Product Change Notification - SYST-15KSKY745

ERRATA - PIC24FJ64GB004 Silicon/Data Sheet Errata

Description of Change: Added silicon issue 21 (Deep Sleep).

PIC24FJ64GB004 Family Silicon Errata and Data Sheet Clarification

FIGURE 2-3 FREQUENCY vs. ESR PERFORMANCE FOR SUGGESTED VCAP

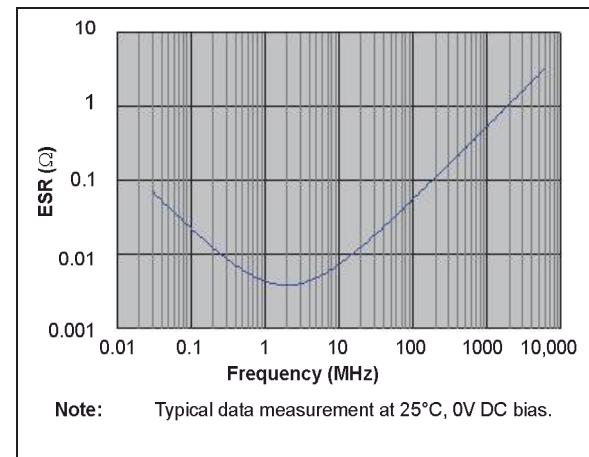
Section 2.4 Voltage Regulator Pins (ENVREG/DISVREG and VCAP/VDDCORE) has been replaced with a new and more detailed section. The entire text follows:

When the regulator is enabled, a low-ESR ($< 5\Omega$) capacitor is required on the VCAP/VDDCORE pin to stabilize the voltage regulator output voltage. The VCAP/VDDCORE pin must not be connected to VDD and must use a capacitor of 10 μF connected to ground. The type can be ceramic or tantalum. Suitable examples of capacitors are shown in **Table 2-1**. Capacitors with equivalent specifications can be used.

Designers may use **Figure 2-3** to evaluate ESR equivalence of candidate devices.

FIGURE 2-4 DC BIAS VOLTAGE vs. CAPACITANCE CHARACTERISTICS

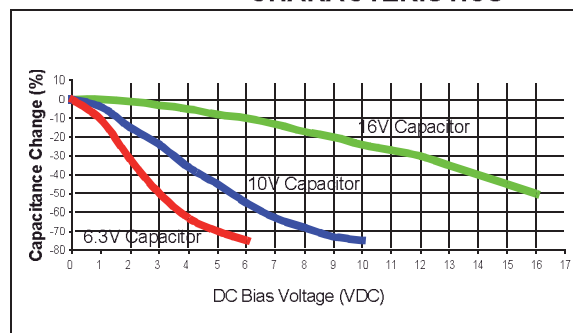
In addition to temperature tolerance, the effective capacitance of large value ceramic capacitors can vary substantially, based on the amount of DC voltage applied to the capacitor. This effect can be very significant, but is often overlooked or is not always documented.

A typical DC bias voltage vs. capacitance graph for 16V, 10V and 6.3V rated capacitors is shown in Figure 2-4.

When selecting a ceramic capacitor to be used with the internal voltage regulator, it is suggested to select a high-voltage rating, so that the operating voltage is a small percentage of the maximum rated capacitor voltage. For example, choose a ceramic capacitor rated at 16V for the 2.5V core voltage. Suggested capacitors are shown in Table 2-1.

FIGURE 29-1: PIC24FJ64GB004 VOLTAGE-FREQUENCY GRAPH (INDUSTRIAL)

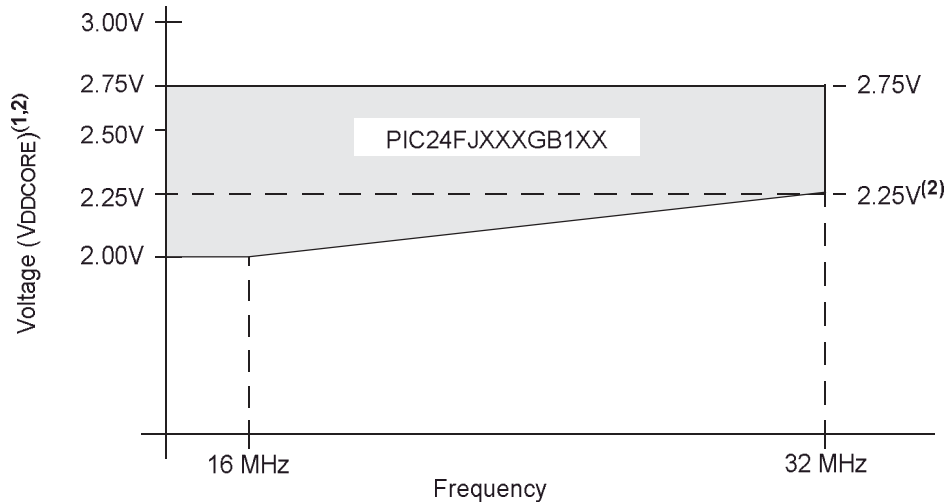
Figure 29-1 ("PIC24FJ256GB110 Family Voltage-Frequency Graph") is amended by adding an additional footnote. The updated figure is shown below (changes in **bold**; bold in original removed for clarity).

For frequencies between 16 MHz and 32 MHz, $F_{MAX} = (64 \text{ MHz/V}) * (V_{DDCORE} - 2V) + 16 \text{ MHz}$.

- Note 1:** When the voltage regulator is disabled, VDD and VDDCORE must be maintained so that $V_{DDCORE} \leq V_{DD} \leq 3.6V$.
- 2:** When the USB module is enabled, VUSB should be provided at 3.0V to 3.6V, while VDDCORE must be 2.35V. When the USB module is not enabled, the wider limits shaded in grey apply. The voltage on the VUSB pin should be maintained at (VDDCORE – 0.3V) or greater; optionally, the pin may be left in a high-impedance state when the USB module is not in use, but doing so may result in higher IPD currents than specified.

28-Lead Plastic Small Outline (SO) - Wide, 7.50 mm Body [SOIC]

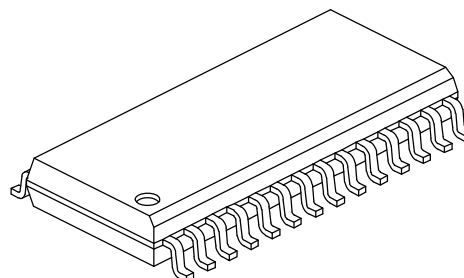
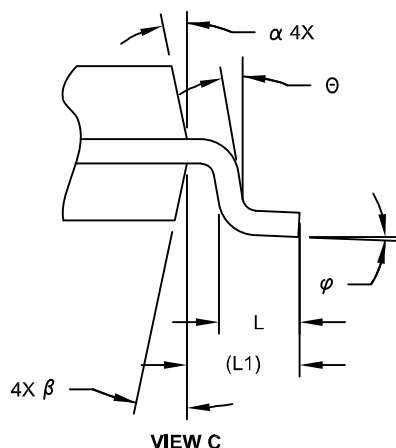
Section 30.0 “Packaging Information” omits the drawings for 28-pin SOIC packages (7.5 mm, type SO), which are a valid packaging option for this device family. The applicable Microchip drawings (C04-052C, two sheets, and C04-2052A) are added to the section. They appear on the following pages.
